**Summary Report:  
Conceptual Model Review and Remediation Options  
for Los Alamos National Laboratory  
Technical Area 54, Material Disposal Area L**

LANL TA54 MDA L Technical Advisory Group

Comments Topic:		ITRD LANL MDA L TAG Subteam Report: Conceptual Modeling for MDA L, Draft Rev. 2, April 4, 2002		April 25, 2002
#	COMMENT SOURCE	COMMENT	RESPONSE SOURCE	RESPONSE

Figure 2. Generalized Cross-Section at Los Alamos National Laboratory

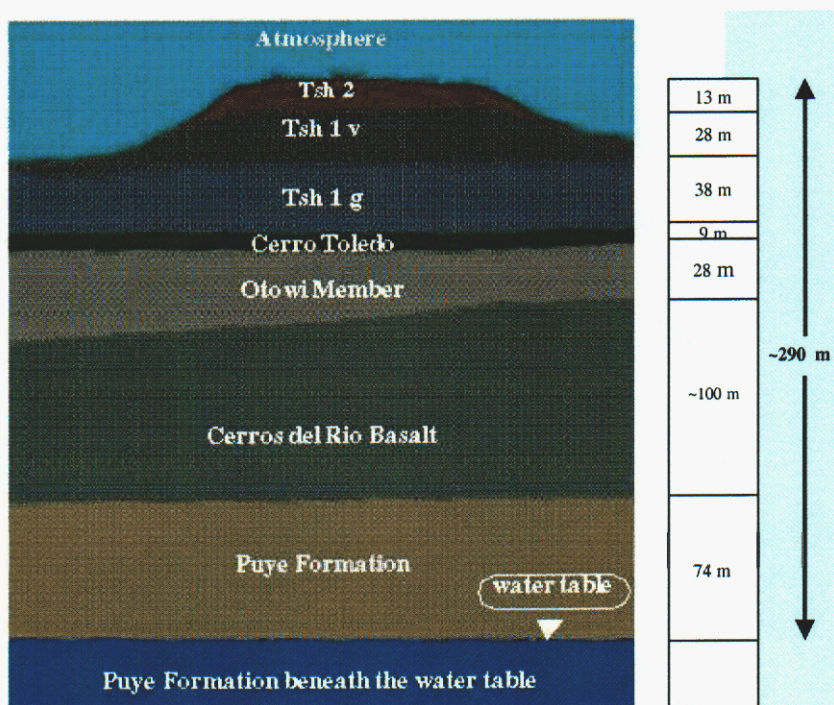
At the time the report was written, no core sample measurements were available for the Cerros del Rio Basalts (Figure 2). Therefore, the numerical model was formulated using a surrogate porosity and a modeled saturation value. Further refinements to the numerical simulations can be realized if property measurements can be made on the basalts via the deep wells.

Isn't the Cerros del Rio Basalts formation fractured in places? Inclusion of these fractures could significantly increase vertical migration towards the water table. I seem to recall that there are very few measurements under the plume in this formation - please correct me if I'm wrong.
